**FINAL**  
**Environmental Impact Report**  
**Rio Vista Specific Plan Project**  
**City of Jurupa Valley, Riverside County, California**  
**State Clearinghouse Number 2018121005**

Date: May 31, 2024

**Subject: Draft Environmental Impact Report, Rio Vista Specific Plan Project, State Clearinghouse No. 2018121005, City of Jurupa Valley**

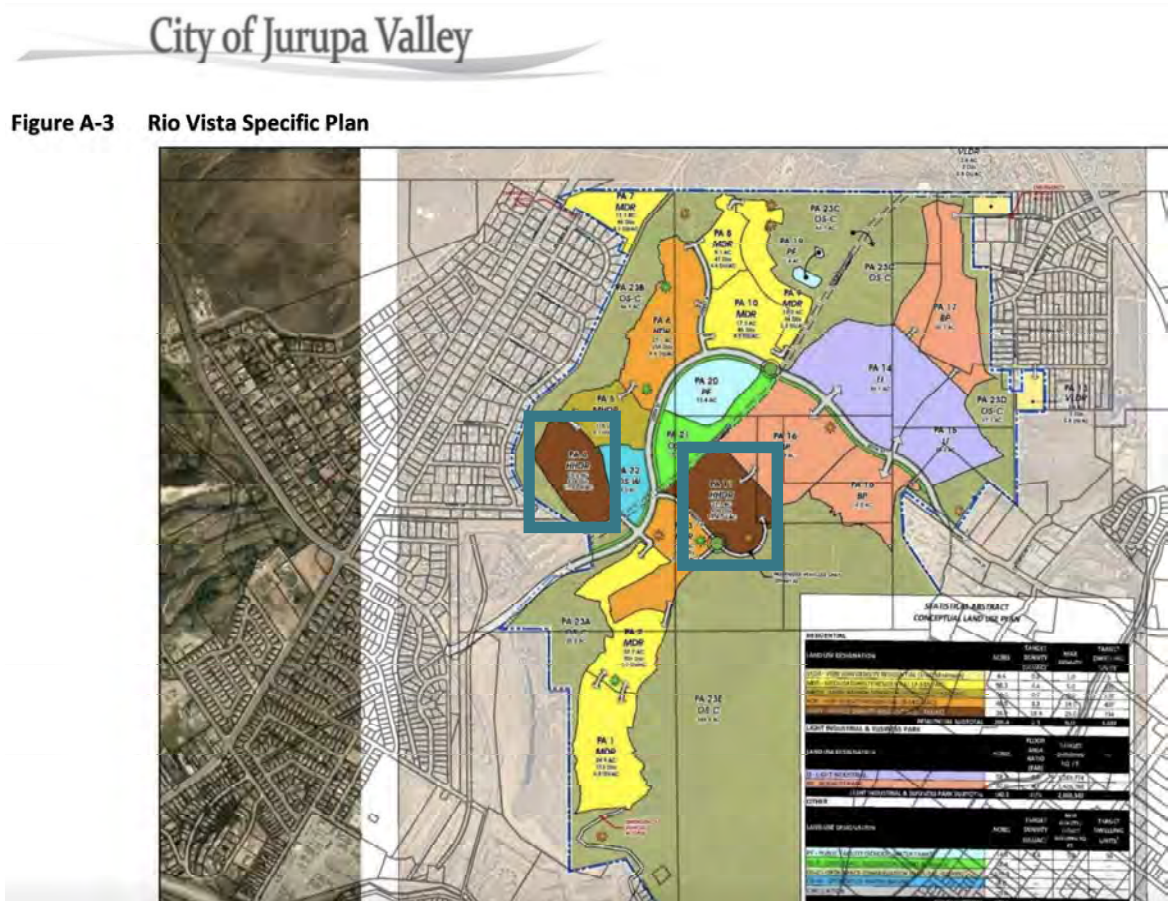
Additionally, Figure A-3 from the Housing Element depicted below demonstrates that many of the Planning Areas in the proposed SP have changed, including the residential density for each SP. Table 5.40: Proposed Rio Vista Specific Plan Amendment (2021) Anticipated Build-Out 2021-2029 within the Housing Element states that PA 4 and PA 11 will provide 440 moderate income multi-family housing units in order for the City to accommodate its RHNA.

Notably, PA 4 and PA 11 within Figure A-3 from the Housing Element have changed significantly from the document and analysis approved by the State of California Department of Housing and Community Development (HCD). These PAs are of the highest level of concern because the HCD certified Housing Element states that they will accommodate 440 moderate income units.

The proposed project is consistent with the Housing Element and no amendments are required. It is important to note that the proposed project was anticipated and evaluated in the Housing Element rather than the approved Specific Plan. See Housing Element Table 5.40: Proposed Rio Vista Specific Plan Amendment (2021) Anticipated Build-Out 2021-2029 and Table 5.46: Progress in Meeting 6th Cycle Regional Housing Need Allocation. PA 11 as identified in the Housing Element (see e.g., Figure A-3), is PA 9 in the proposed project (see Figure II-1).
